PIC16CR64 Rev. A Silicon Errata Sheet

The PIC16CR64 (Rev. A) parts you have received conform functionally to the Device Data Sheet (DS30234D), except for the anomalies described below.

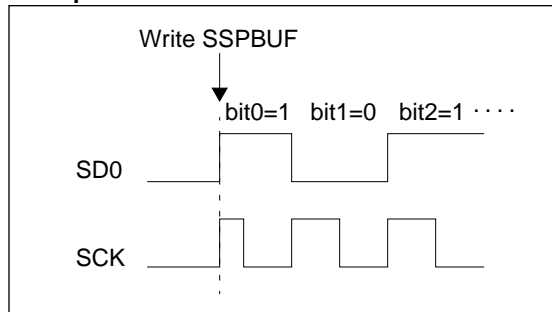
When the SPI is using Timer2/2 as the clock source, a shorter-than-expected SCK pulse may occur on the first bit of the transmitted/received data.

To avoid producing the short pulse, turn off Timer2 and clear the TMR2 register, load the SSPBUF with the data to transmit, and then turn Timer2 back on.

FIGURE 1: WRITES TO TIMER1 (EXTERNAL CLOCK / OSCILLATOR MODE)

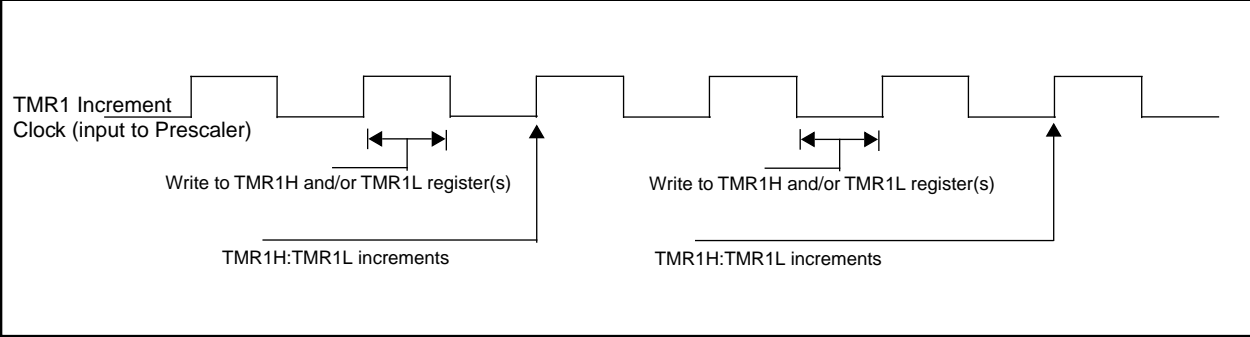
- a) The operation of Timer1 needs some clarification when the timer registers are written when the TMR1ON bit is set.

The internal clock signal that is the input to the TMR1 prescaler affects the incrementing of Timer1 (TMR1H:TMR1L registers and the Timer1 prescaler). When the Timer1 registers are NOT written, the Timer1 will increment on the rising edge of the TMR1 increment clock.

When the TMR1H and/or TMR1L registers are written while this clock is high, TMR1 will increment on the next rising edge of this clock.

When the TMR1H and/or TMR1L registers are written while this clock is low, TMR1 will not increment on the next rising edge of this clock, but must first have a falling clock and then the rising clock for TMR1 to increment.

Figure 1 shows the two cases of writes to the TMR1H and/or TMR1L registers. Due to the V_{IH} and V_{IL} thresholds on the oscillator/clock pins, external Timer1 oscillator components, and external clock frequency, the Timer1 increment clock may not be of a 50% duty cycle.

The TMR1 increment clock is out of phase of the T1OSO/T1CKI pin by a small propagation delay.
